# RESPONSE TO CUMBERLAND DESIGN EXCELLENCE PANEL COMMENTS – DA2020/0542

14–22 MARY STREET,  
AUBURN

## Response to Cumberland DEP Issues - 14-22 Mary Street, Auburn

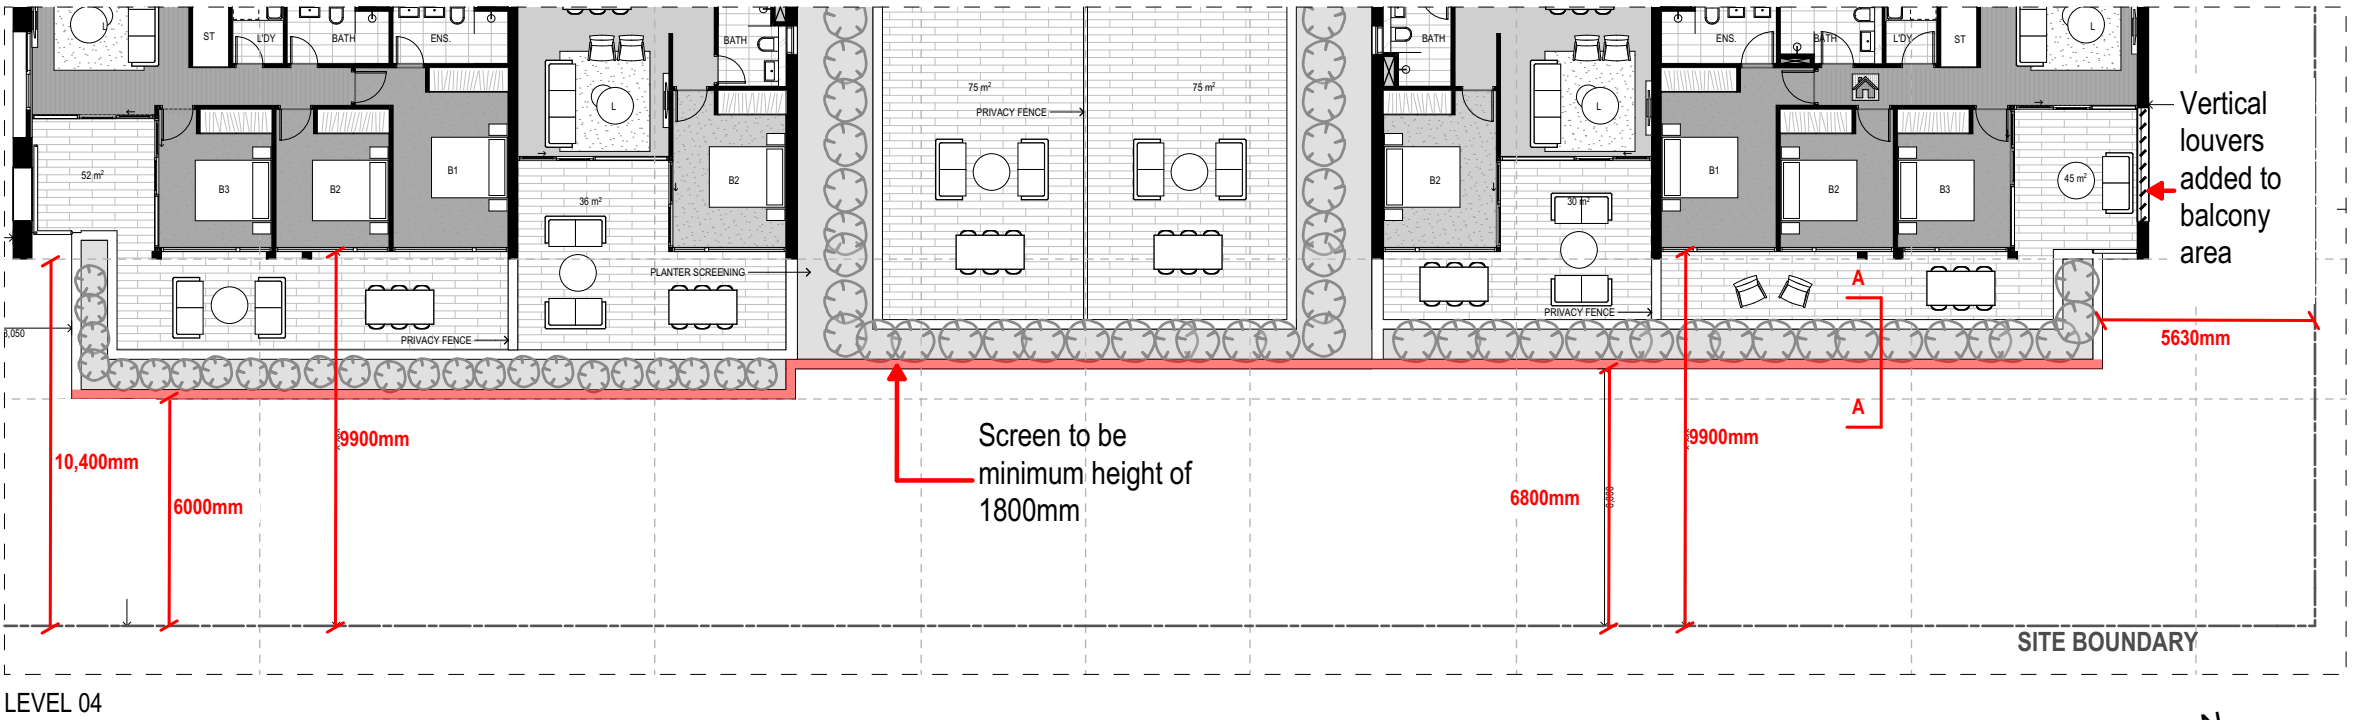
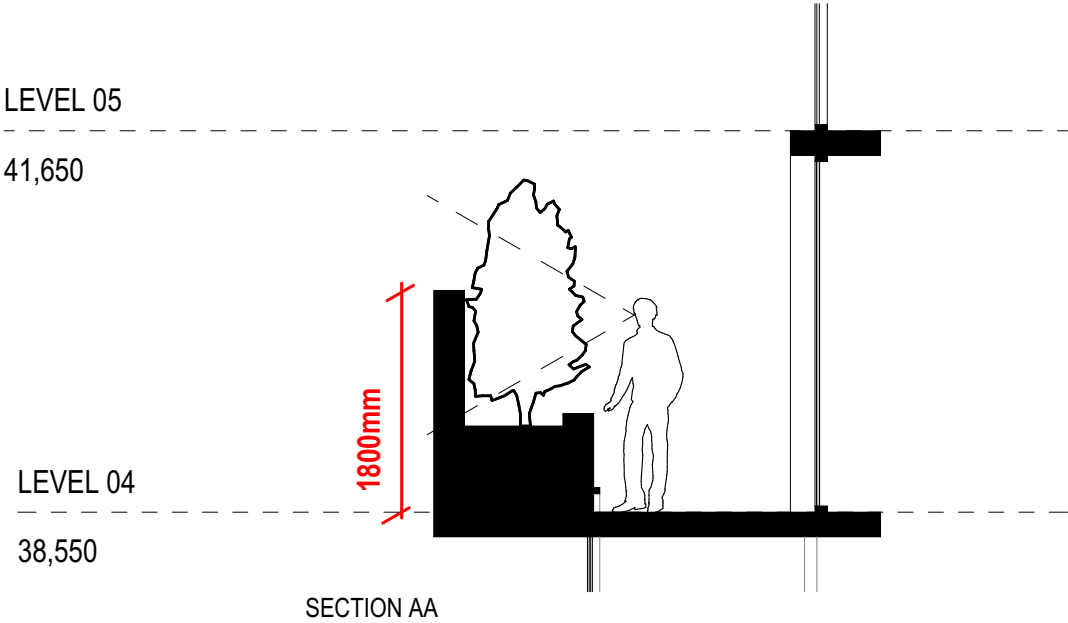
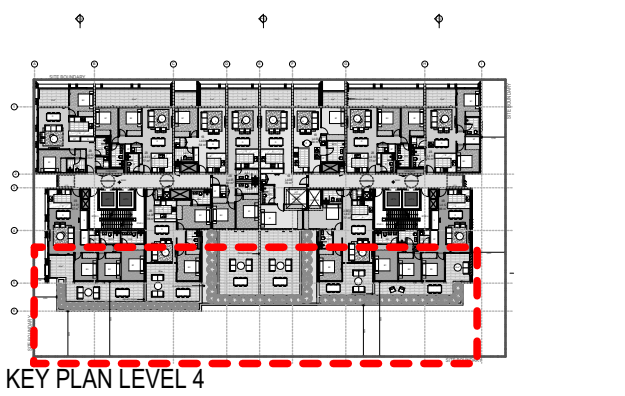
- The setback to the balconies to the rear southern boundary at Level 4 (ie 5th storey) is less than 9m (7m);
- The setback to the balconies and habitable rooms to the rear southern boundary at Levels 8-10 (ie 9th-11th storeys) is less than 12m (9.7m).

In light of the above amended plans should be provided to address the noncompliance at Level 4 to the rear boundary and to indicate the provision of privacy screens to protect the amenity of the property to the east.

1.8m privacy screen added to the southern facade.

Solar amenity for Volume A

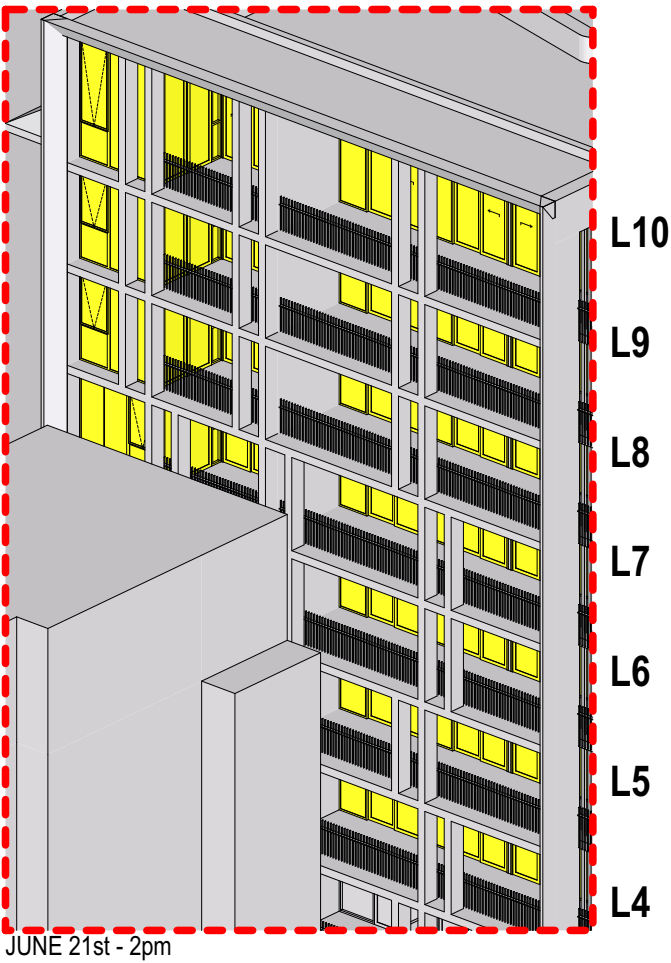
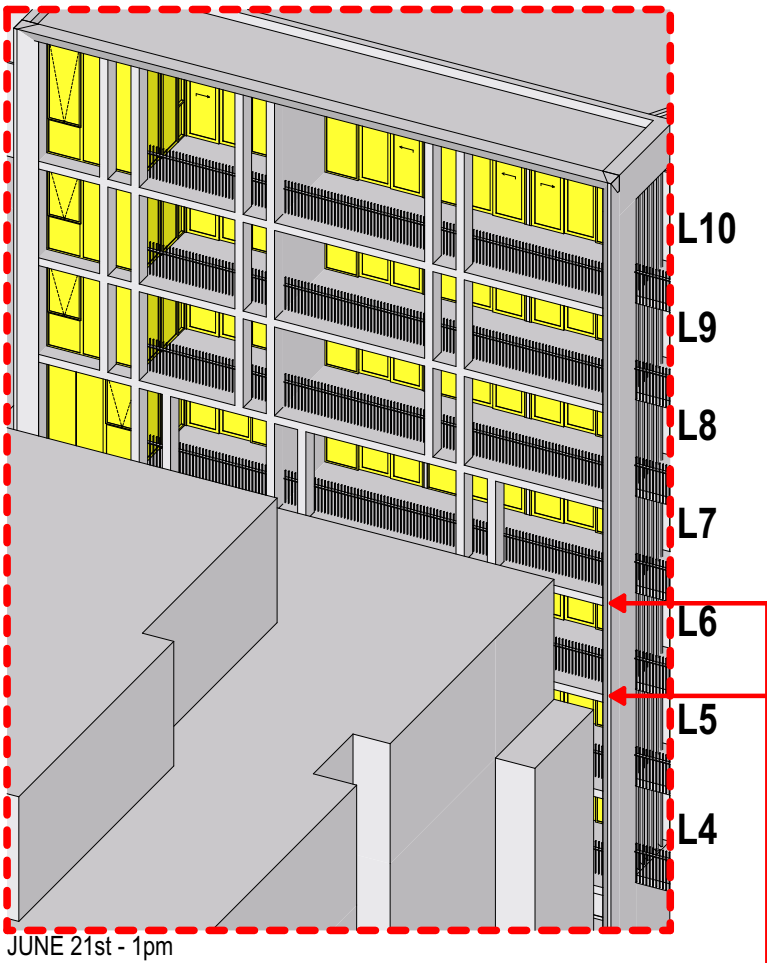
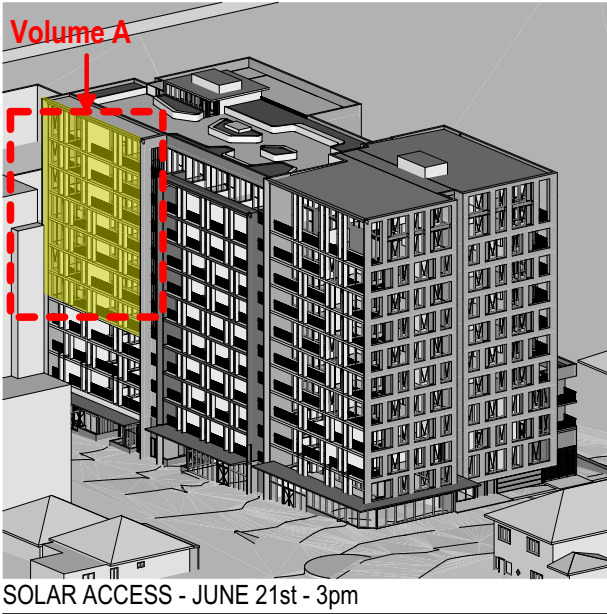
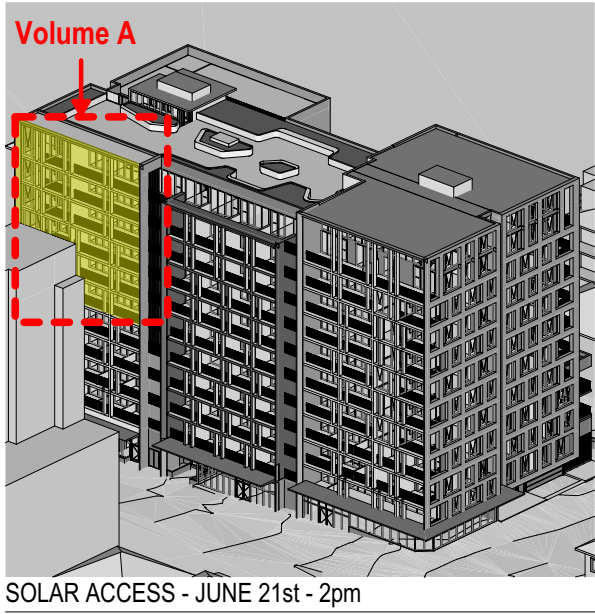
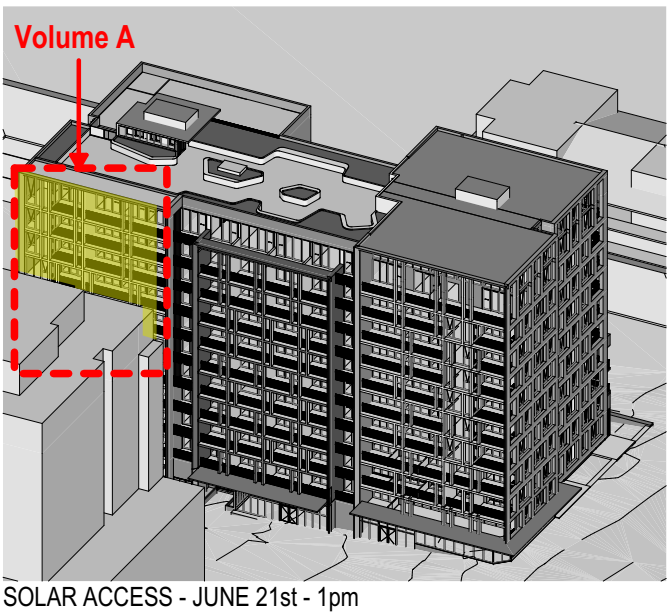
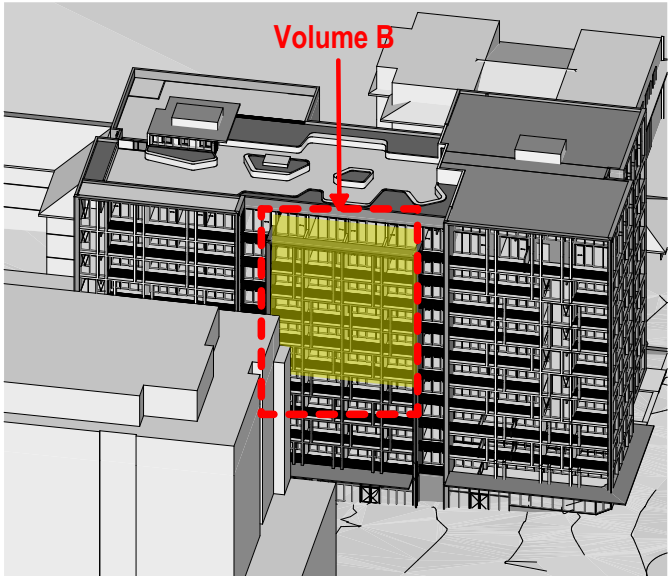
4A Solar and daylight access - The proposal is noted as achieving the 70% solar access at midwinter requirement, however further details are required to confirm this as there is significant overshadowing from the large existing and approved building under construction opposite in Mary Street.

Apartments L5.10 and L6.10 have the ability to receive direct sunlight without obstruction from other buildings or impediments.

LEVEL 04  
SCALE 1:500

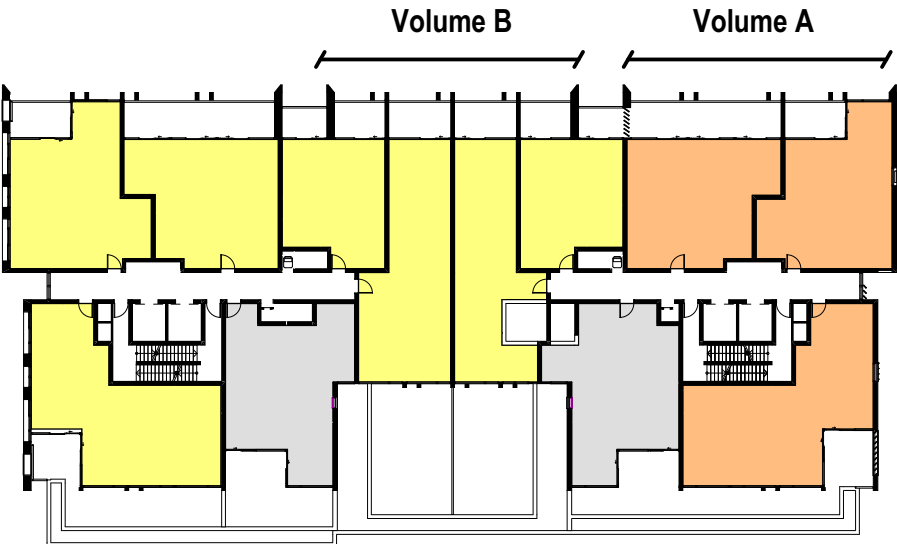
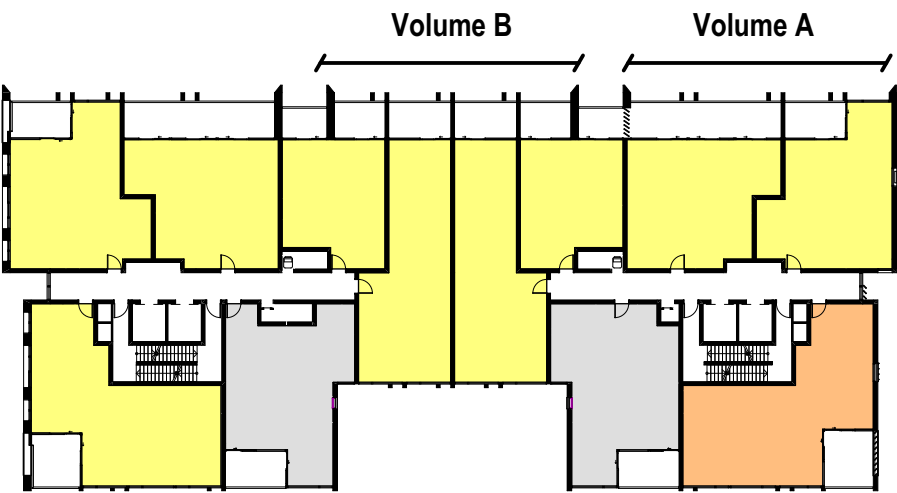
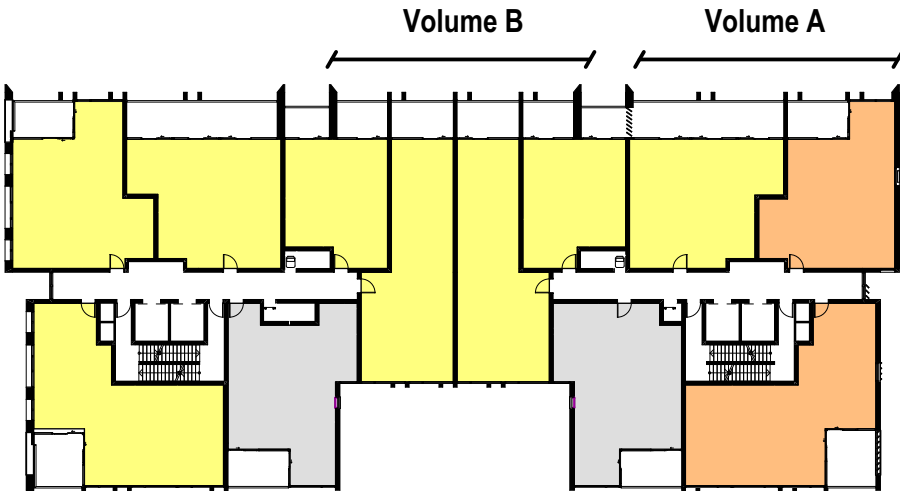
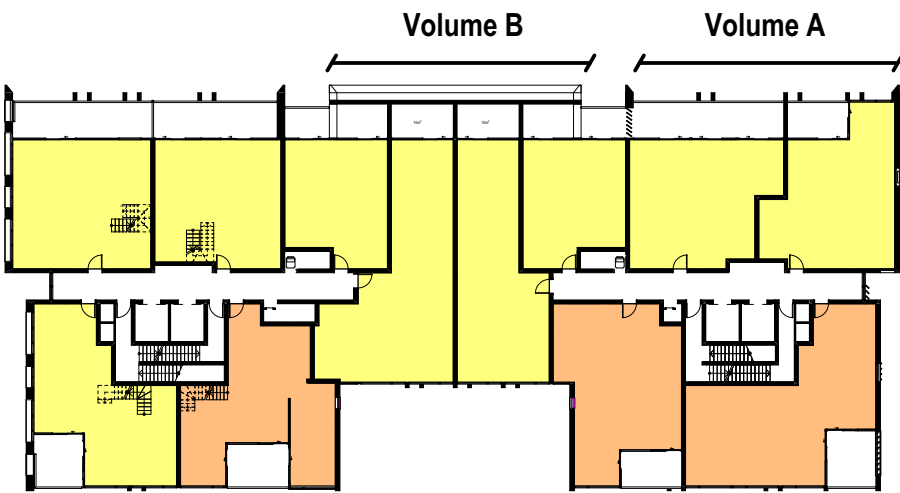
4A Solar and daylight access - The proposal is noted as achieving the 70% solar access at midwinter requirement, however further details are required to confirm this as there is significant overshadowing from the large existing and approved building under construction opposite in Mary Street.

Solar calculations.

landscape plan  
SCALE

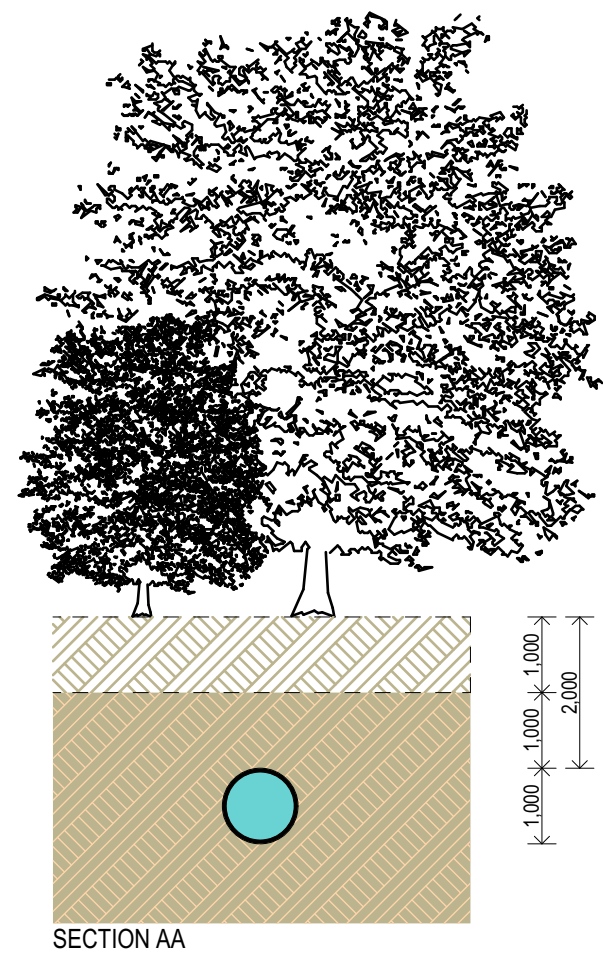
40 Landscape design – concern is raised regarding the removal of large existing trees within the proposed rear setback. Further details are required as discussed below.

In response to addressing the need to remove and replace the existing *Ulmus parvifolia* (Chinese Elm) due to the installation of a new stormwater line in their current location.

In replacing these trees, we will provide a minimum 2metres of soil above the closest section of pipe to the base of the tree.

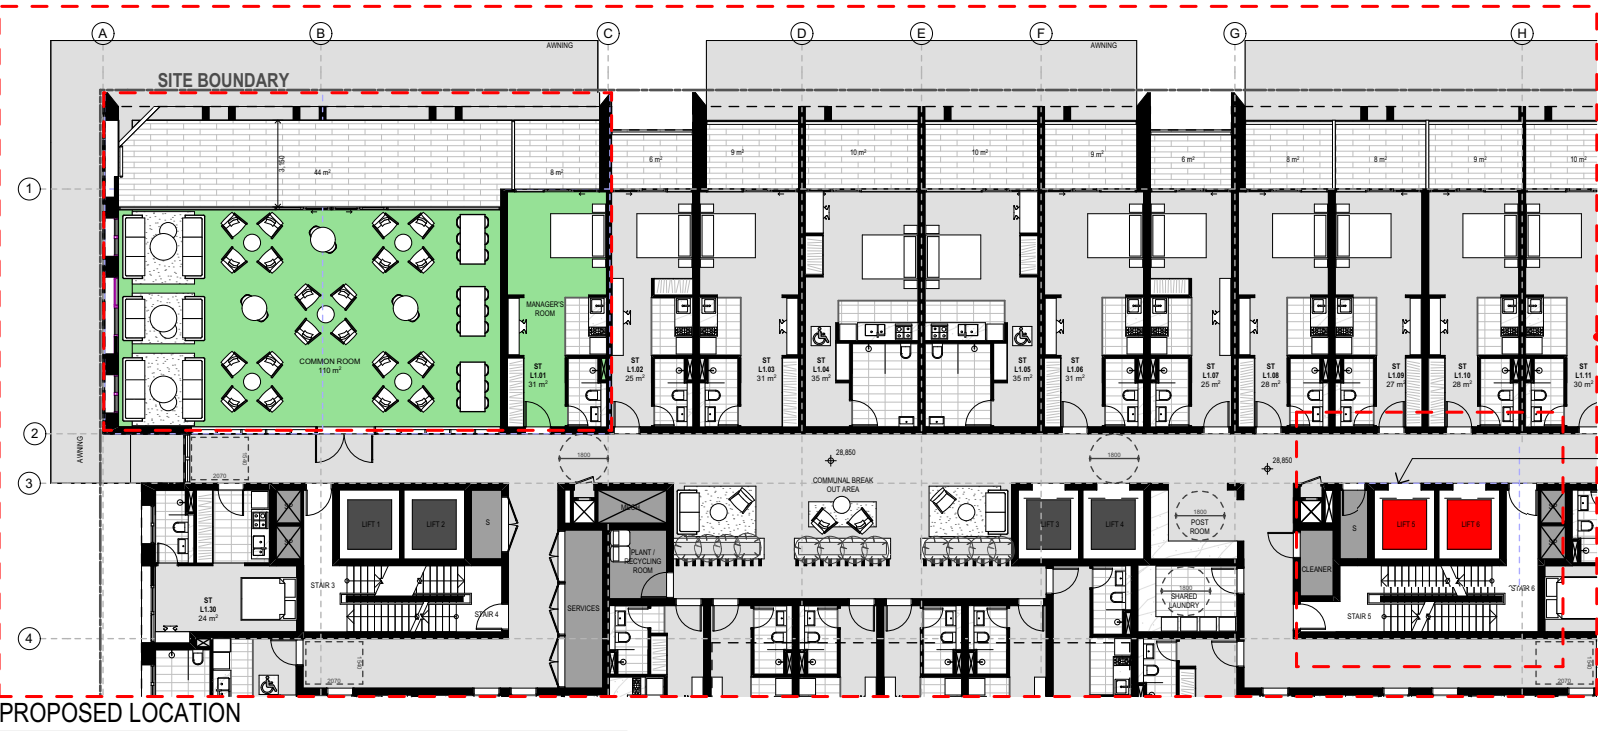
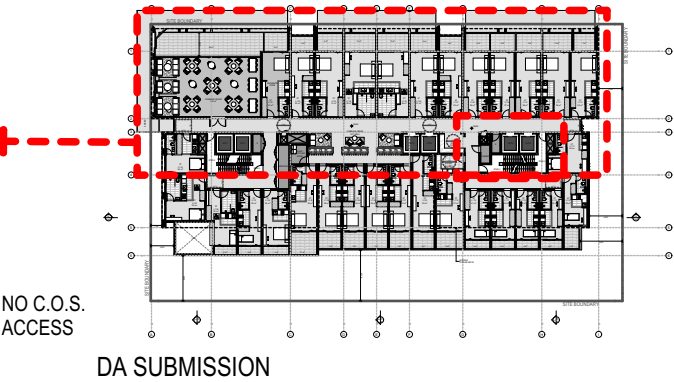
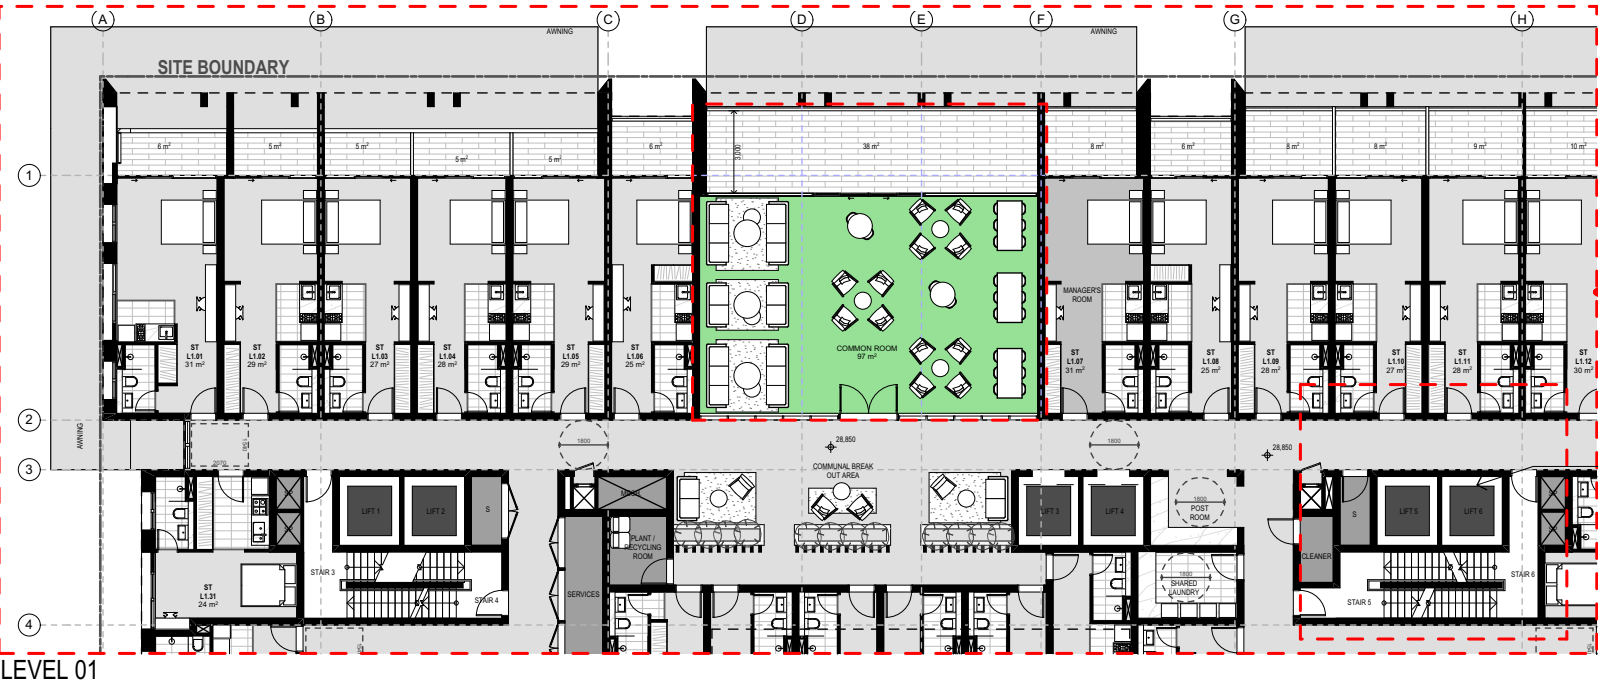
a. Solar access to Communal Room – the proposal complies with the requirement for a min of 3 hours between 9am and 3pm at midwinter, however it is likely that future development will result in non compliance. The rooftop communal space should be made available to the boarding house rooms to ensure ongoing access to an adequately sunny area.

Communal room relocated to the north/west corner for better solar access.  
Lift access for the boarding rooms is provided via lift 05 and 06 to the C.O.S. on the roof.
